Technical Service Information

THM 3L30 (180C) HARSH NEUTRAL DRIVE OR HARSH 3-2 DOWNSHIFT

Figure 1

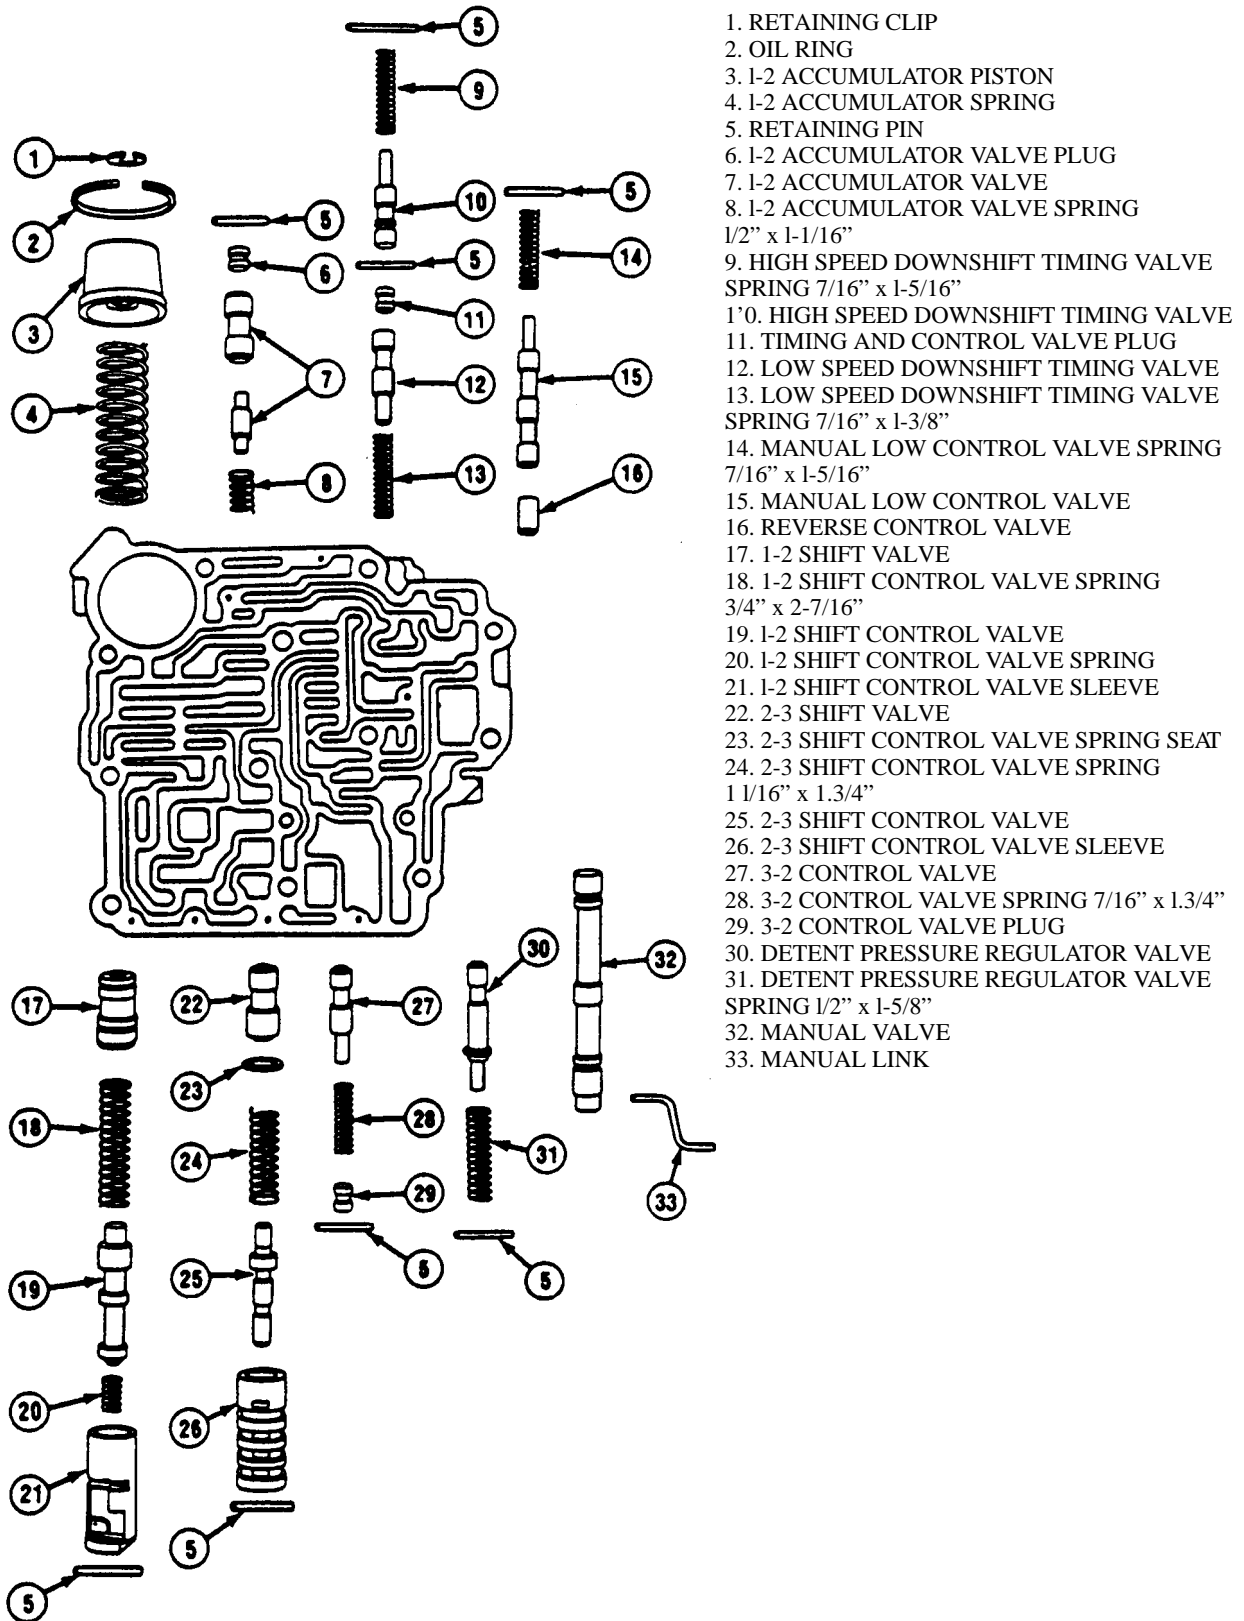
COMPLAINT: Some 1990/1991 model THM 3L30 (180C) transmissions may exhibit a harsh neutral to drive engagement, harsh 3-2 downshifts, or harsh 2-3 lift foot shifts. The transmission may exhibit any or all of the above conditions.

CAUSE: The cause may be mis-calibration.

CORRECTION: There is now available a new calibration update package, OEM part number 96040746, that should be installed. Use Figure 1 for proper assembly and identification.
